Re: Consolidated Edison Company of New York, Inc.
AEC Docket No. 50-247

The attachment supplements the document entitled, "Additional Testimony of Applicant Concerning Emergency Core Cooling System Performance", dated July 13, 1971. The attachment responds to questions raised orally by the Division of Reactor Licensing and which were discussed with the staff at a meeting on August 13, 1971.

ADDITIONAL INFORMATION ON EMERGENCY CORE COOLING ANALYSIS

FIGURE 1

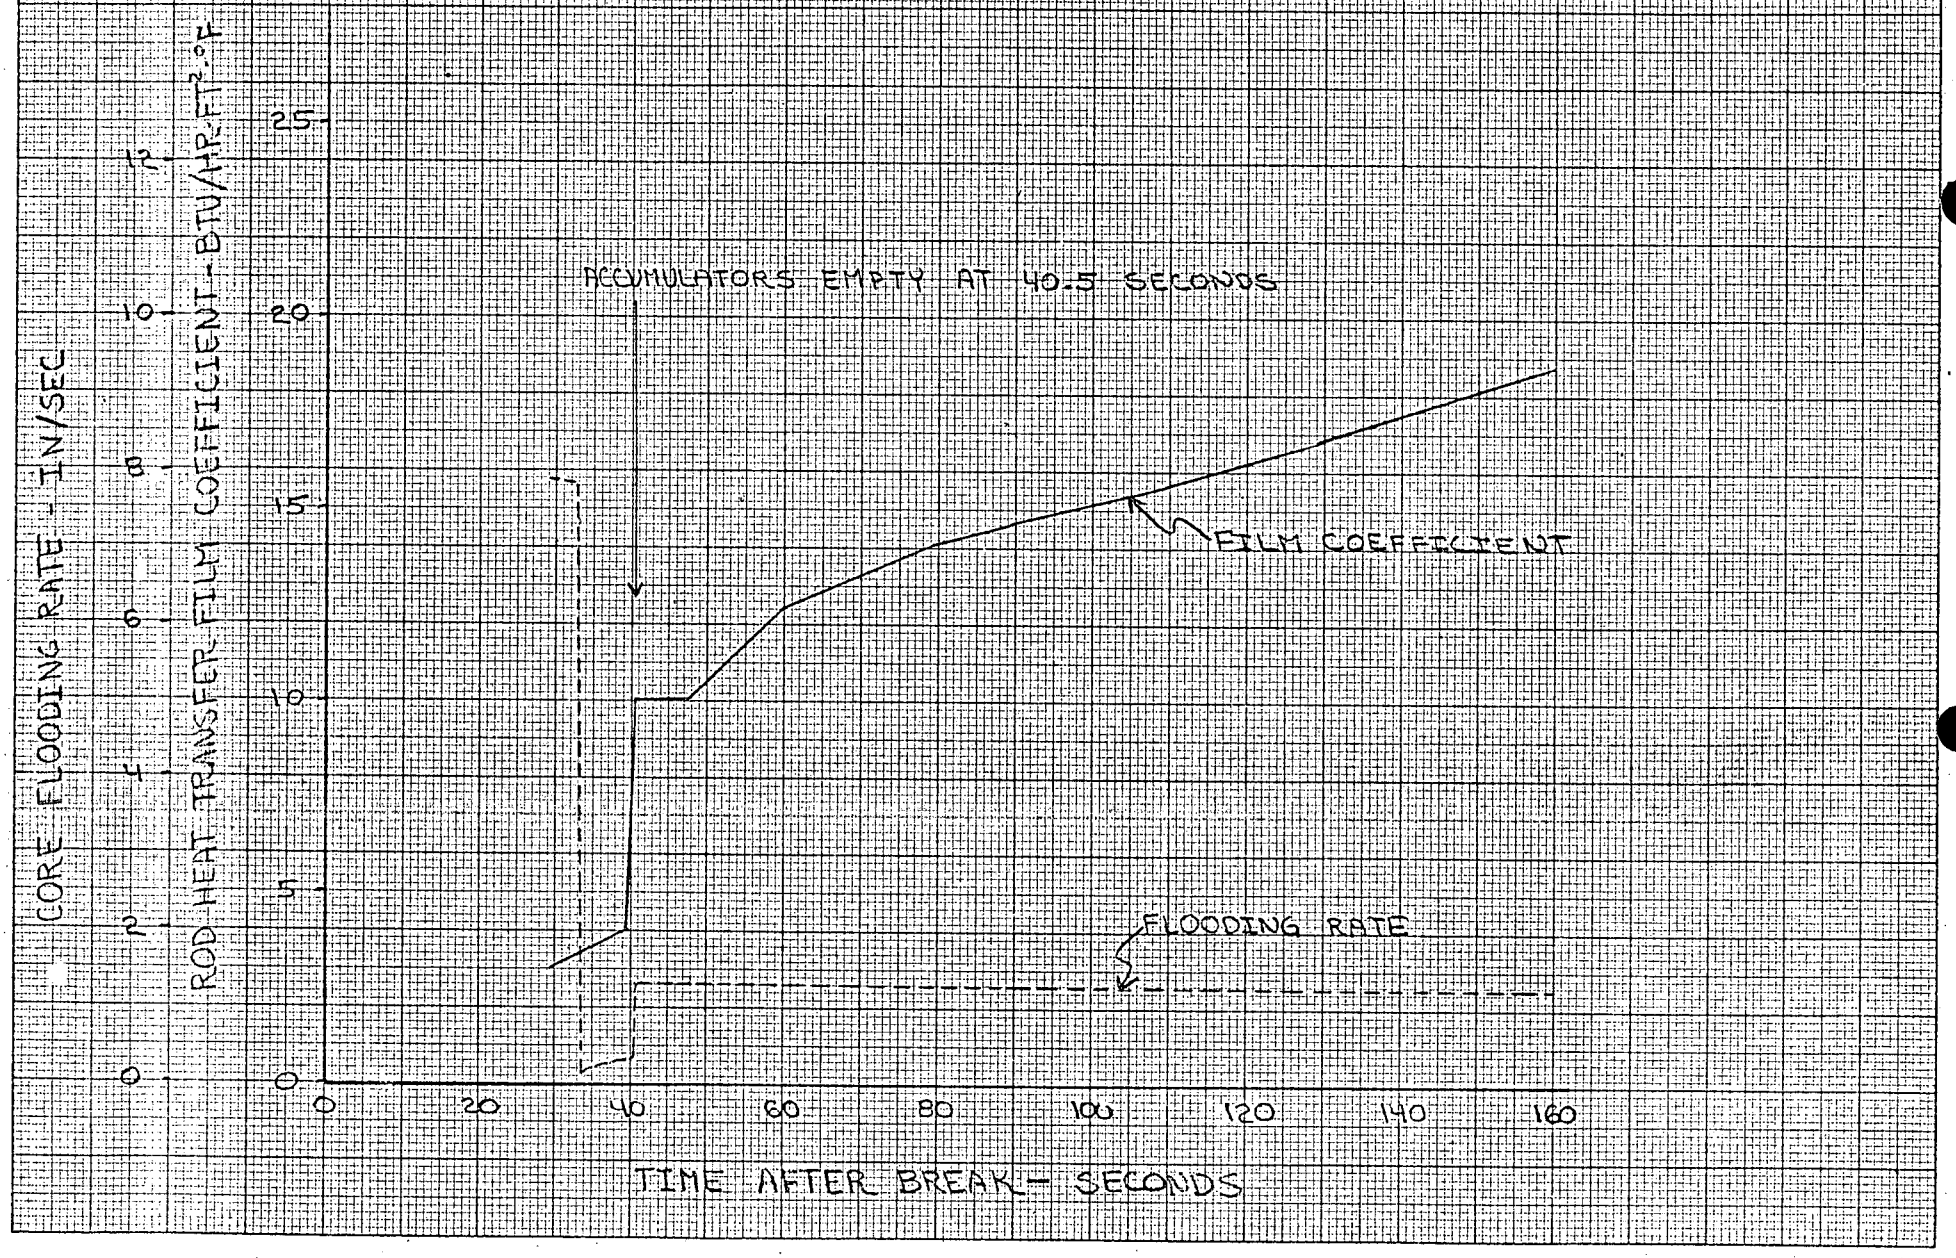
Figure 1 is a plot of both the core flooding rate and the hot spot film heat transfer coefficient as a function of time used in the double-ended cold leg break Loss of Coolant Analysis. The time that the accumulators empty is also indicated on the graph.

FIGURE 27
.8 DE Break

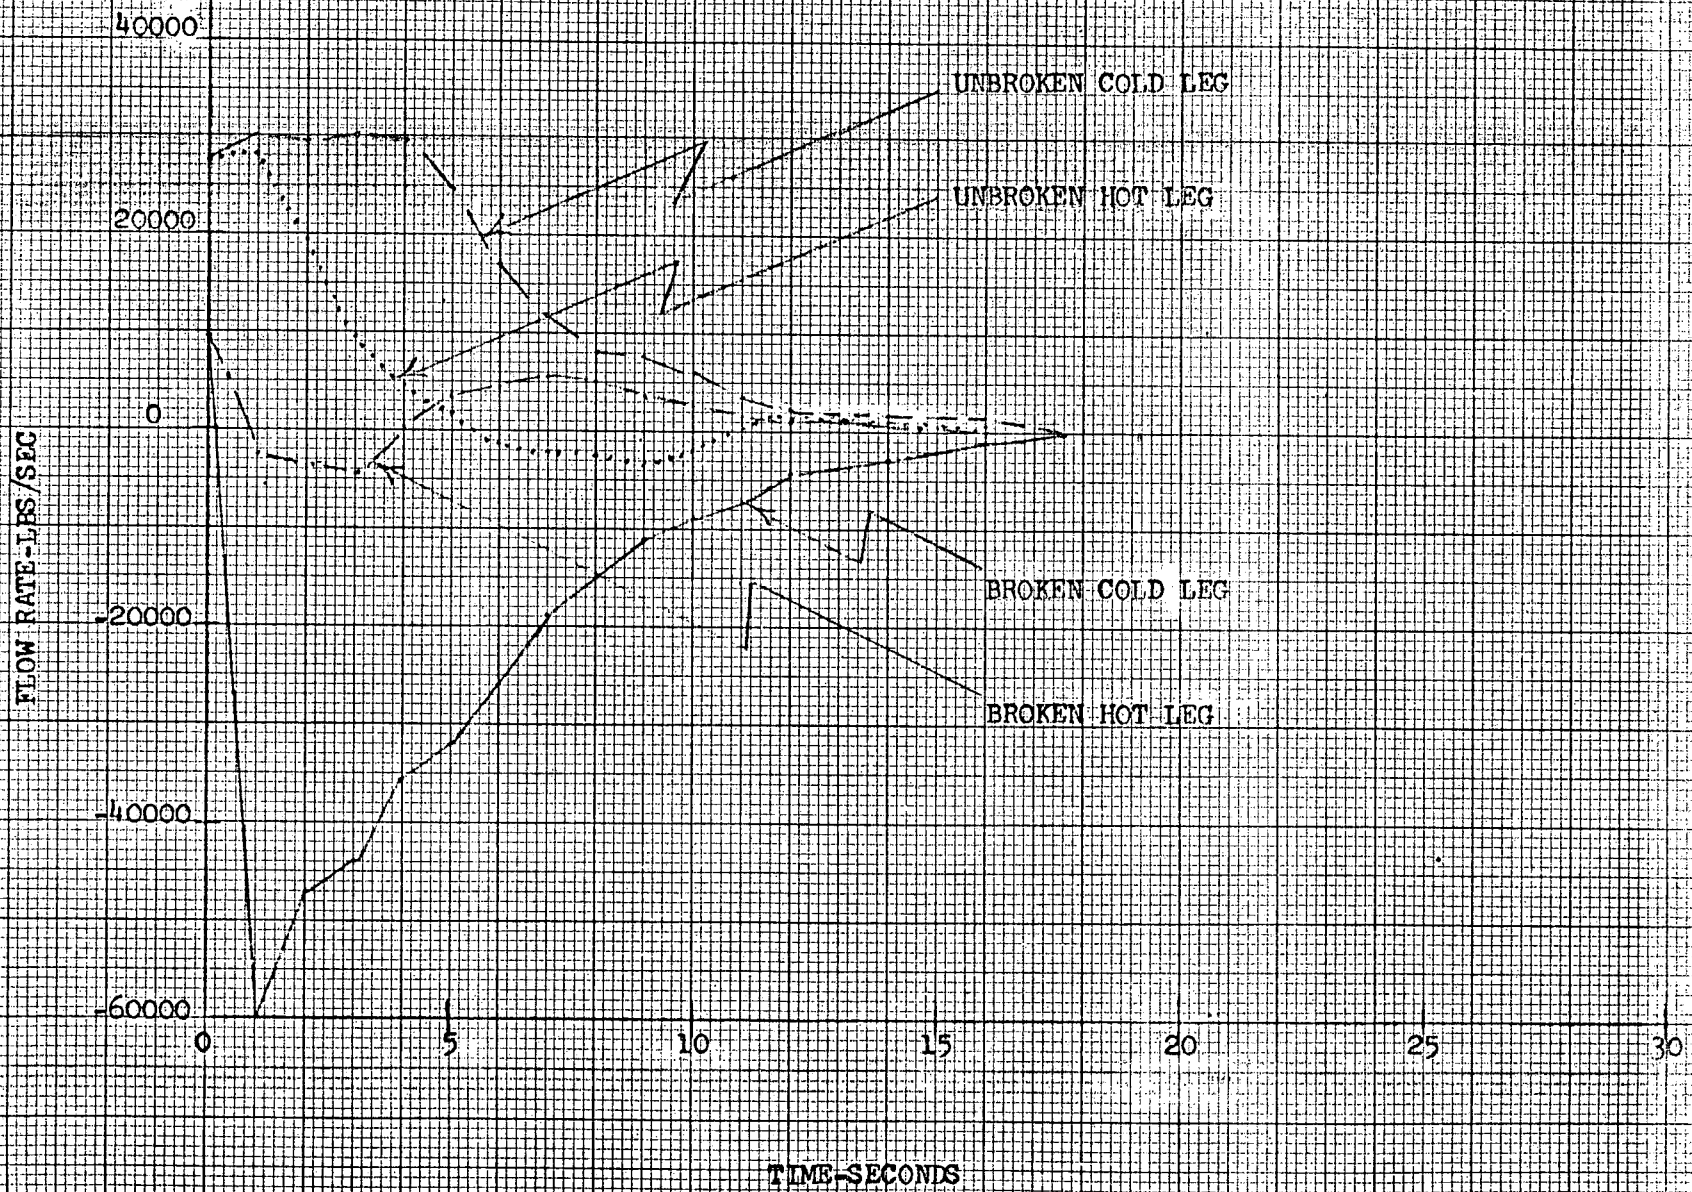
Items 1 and 2 provide additional details on the reflooding analysis and an analysis of the 0.5 square foot cold leg break. Items 3 and 4 provide clarifying information which demonstrates that the analysis in the above-mentioned document is in accordance with Appendix A, Part 3, of the Commission's interim policy statement. There is also included in the attachment a replacement for Figure 27 to correct a typographical error in identifying the broken hot leg curve.

Replacement for Fig. 27 to correct a typographical error.
